# HISTORIC DISTRICT COMMISSION

## CERTIFICATE OF APPROPRIATENESS

**Application Number:** HDC2025-00591

**Project Address:** 2233 Park Avenue

ORIGINAL AND NEW WINDOW ELEVATION COMPARISON

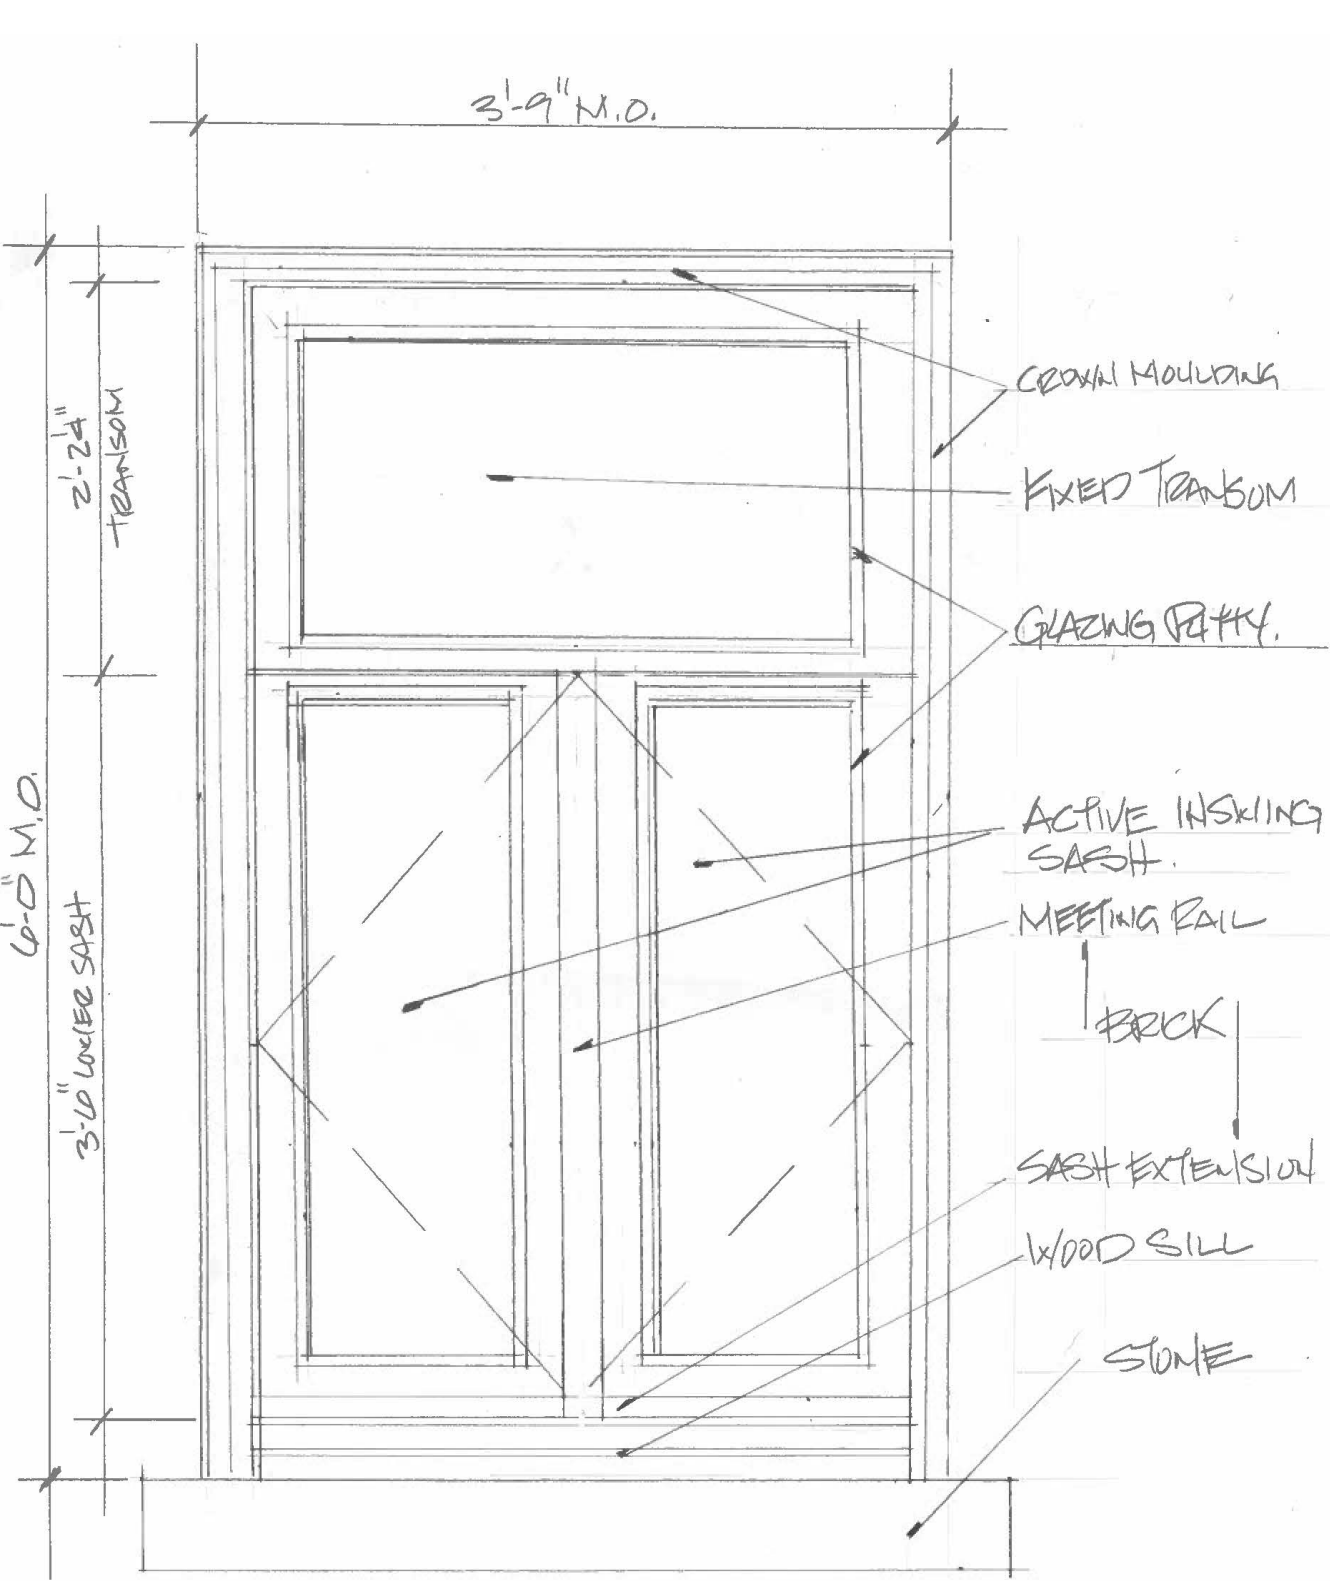
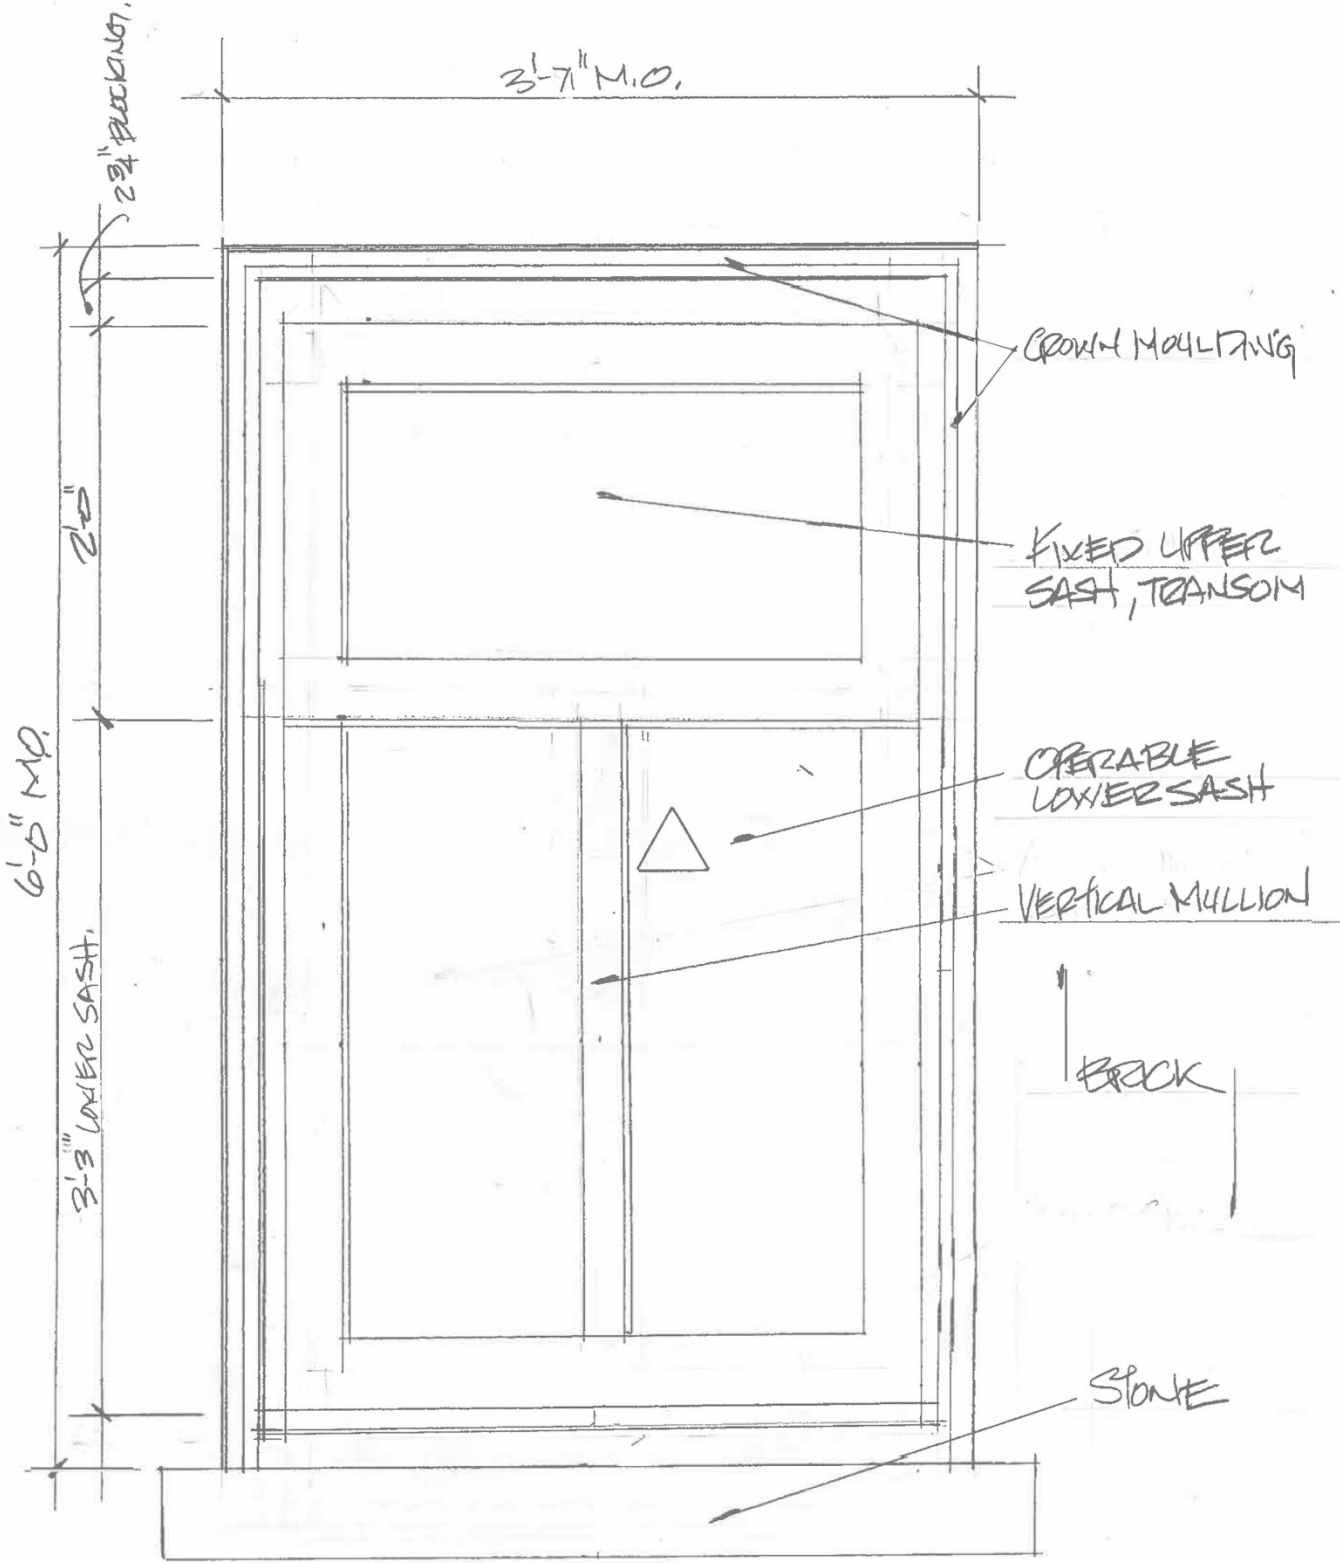
- the proposed vertical strip on the lower sash of the cottage window will be six inches wide rather than three inches wide.
